GROUP <b>BOD</b>	MODEL <b>Sportage (QL)</b>
	NUMBER <b>142</b>	DATE <b>July 2016</b>
<b>TECHNICAL SERVICE BULLETIN</b>		
<b>SUBJECT:</b>	<b>SERVICE ACTION: REAR DOOR FRAME MOLDING REPLACEMENT (SA 236)</b>

This bulletin provides the procedure for replacing the rear door frame molding on certain Sportage (QL) SX trim level vehicles produced from December 24, 2015 through January 26, 2016, due to the possibility of molding separation.

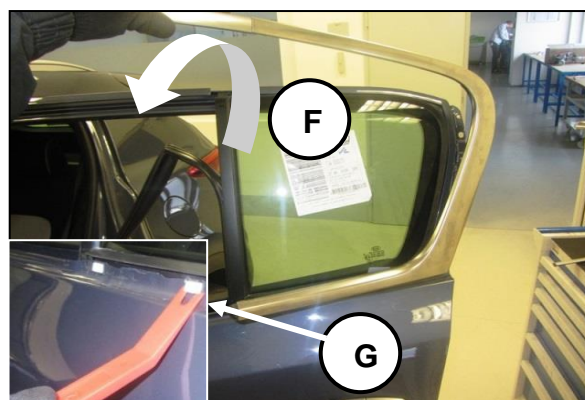
6. Remove the door molding from both sides and replace them with new ones (F).

Part Name	Part Number		Remark
	Previous	New	
Molding Assembly RR DR Frame Set	83860D9010 RH 83850D9010 LH	 83850D9010QQK	Parts are delivered in a kit containing frames for both sides.
